February 25, 2022  
E-60459

Subject: Application for Amendment 3 to NUHOMS® EOS Certificate of Compliance No. 1042, Revision 5 (Docket 72-1042, CAC No. 001028, EPID: L-2021-LLA-0055) – Response to Request for Additional Information (New Scope) and Revised Responses to Request for Additional Information

List of New CoC 1042 Amendment 3, Revision 5 Technical Specifications  
Changes and Justifications

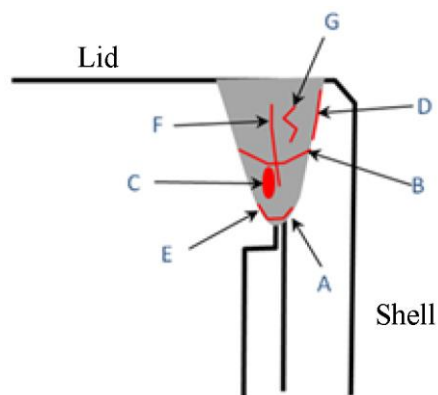
Provide the following additional information on the proposed phased array ultrasonic testing (UT) system for the detection of flaws in the multi-pass gas tungsten arc welding (GTAW) and single pass high amperage gas tungsten arc welding (HA-GTAW) outer top cover plate (OTCP) welds:

1. Clarify whether the proposed phased array ultrasonic testing (UT) system would be used to inspect the multi-pass gas tungsten arc welding (GTAW) as an alternative to the multi-level PT examination.
2. Describe the type, size, and orientation of the flaws that may be present in the OTCP weld(s) examined using the phased array UT system.
3. Describe the UT demonstration procedure including the mockup(s) for the OTCP weld(s) including the single-pass HA-GTAW weld and, if applicable, the multi-pass GTAW weld, a description of the type, size, and orientation of flaws in the that will be inserted into the OTCP weld mockup(s) to represent the flaws that may be present in the OTCP weld(s), the required probability of detection (POD) for the phased array UT of the OTCP weld(s), and how the POD will be determined.

It is not clear whether the phased array UT examination, conducted from the external surface of the OTCP, will be able to detect and size weld flaws such as lack of fusion. For the multi-pass GTAW OTCP weld, phased array UT was shown to be an acceptable method for lack of fusion flaws when the examination was conducted from the outer diameter of the DSC shell (ML16159A227). The phased array UT application reviewed by the NRC in ML16159A227 was determined to be acceptable because the procedure was qualified using a blind performance demonstration in accordance with ASME B&PV Code Section V, Article 14, T-1424(b) with Intermediate Rigor that qualifies the equipment, procedure, and data analysis personnel for the detection and dimensioning of welding fabrication flaws. The previous demonstration does not appear to be applicable to the phased array UT described in the current application because the proposed phased array UT would be conducted from the outer surface of the OTCP rather than the external surface of the DSC shell. Further, the weld joint geometry of the single-pass HA-GTAW OTCP weld appears to be a narrow groove weld. Lack of fusion flaws in the single pass HA-GTAW OTCP weld are likely to be oriented perpendicular to the exterior surface of the OTCP. Because of this likely flaw orientation, it is not clear that the proposed phased array UT method from the exterior of the OTCP will be able to detect and adequately size a lack of fusion flaw in the single-pass HA-GTAW OTCP weld.

1. Even though the HA-GTAW weld is a narrow groove the as-welded cross-sectional dimensions are similar to multi-pass GTAW welds. Thus, the phased array automated ultrasonic testing (PA-AUT) procedure can be qualified for HA-GTAW weld and multi-pass GTAW welds.
2. Minimum detectable and assessable flaw type and size width (w) /height (h)

Minimum length of detectable flaw will be the dimension shown for each flaw type.

Flaw type	Size (in.)
A Inadequate penetration (IP)	0.08 h
B Interpass lack of fusion (cold lap)	0.13 w
C Trapped gas (not porosity)	0.13 h/w
D Lack of side wall fusion	0.08 h
E Lack of root fusion	0.08 h/w
F Hot cracking (center vertical)	0.08 h/w
G Solidification cracks	0.08 h/w

1. *PA-AUT will utilize a mockup (Figure RAI 10-1-1) representing the same joint design as used in closure welding. All appropriate reflectors are to be machined into the mockup to create a realistic calibration block. The PA-AUT system will be validated by successfully demonstrating accurately measuring the area of interest of each reflector in the mockup calibration block. The mockup calibration block will have, at a minimum, the 14 reflectors machined into the relevant inspection area and their respective areas of interest as shown in Figures RAI 10-1-2 through RAI 10-1-9 and their respective areas of interest, with examples shown in Figure RAI 10-1-2 and Figure RAI 10-1-6. To accommodate various sound paths (see Figures RAI 10-1-1 through RAI-10-1-13), the orientation of the cutting path used to create the reflector may be altered, as long as it does not interfere with assessing the reflector's area of interest. Since the PA-AUT procedure will need to be approved by an ASTN Level III, additional reflectors may be required per their request.*

4. *The PA-AUT process will be validated by utilizing a mockup joint design where known flaws sizes will be employed to verify that the appropriate reflector response is detected and displayed.*
